RESPONSE TO REQUEST FOR ADDITIONAL INFORMATION

APR1400 Design Certification

Docket No. 52-046

RAI No.: 138-8067
SRP Section: 16 - Technical Specifications
Application Section: 16.3.0 LCO and SR Applicability
Date of RAI Issued: 08/07/2015

Figure B 3.0-1
 Configuration of Trains and Systems

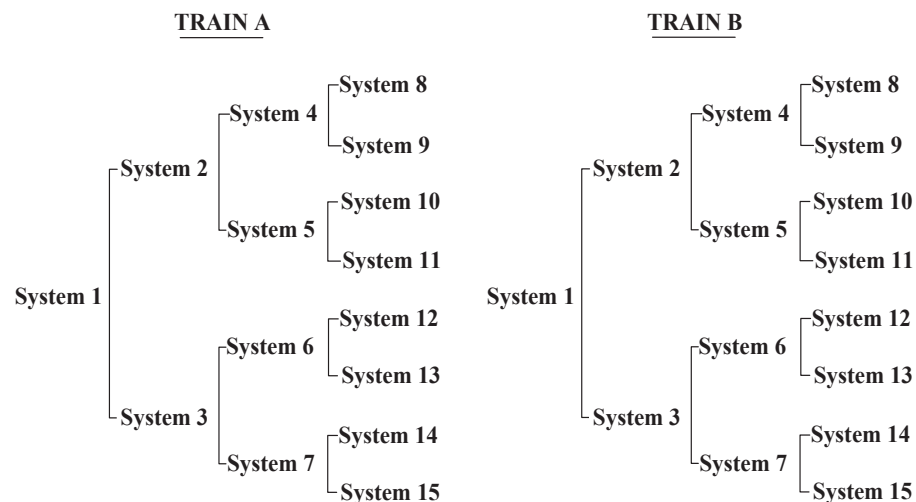
After the fourth paragraph in the LCO 3.0.6 Bases there are numerous wording changes from the STS LCO 3.0.6 Bases, including the entire last paragraph of the STS LCO 3.0.6 Bases being left out in the generic TS LCO 3.0.6 Bases. The Deviation Report, "APR1400-K-O-NR-14001-NP," does not address these differences. Justify the differences or make corrections.

The LCO 3.0.6 Bases will be modified to be consistent with the content and wording of STS B 3.0.6.

The following examples use Figure B 3.0-1 to illustrate loss of safety function conditions that may result when a TS support system is inoperable. In this figure, the fifteen systems that comprise Train A are independent and redundant to the fifteen systems that comprise Train B. To correctly use the figure to illustrate the SFDP provisions for a cross train check, the figure establishes a relationship between support and supported systems as follows: the figure shows System 1 as a support system for System 2 and System 3; System 2 as a support system for System 4 and System 5; and System 4 as a support system for System 8 and System 9. Specifically, a

- a. A **required** system redundant to system(s) supported by the inoperable support system is also inoperable (EXAMPLE B 3.0.6-1),
- b. A **required** system redundant to system(s) in turn supported by the inoperable supported system is also inoperable (EXAMPLE B 3.0.6-2), or
- c. A **required** system redundant to support system(s) for the supported systems (a) and (b) above is also inoperable (EXAMPLE B 3.0.6-3).

If System 2 of Train A is inoperable, and System 5 of Train B is inoperable, a loss of safety function exists in ~~supported System 5.~~

Systems 5, 10 and 11.

If System 2 of Train A is inoperable, and System 11 of Train B is inoperable, a loss of safety function exists in System 11 ~~which is in turn supported by System 5~~

If System 2 of Train A is inoperable, and System 1 of Train B is inoperable, a loss of safety function exists in Systems 2, 4, 5, 8, 9, 10, and 11.
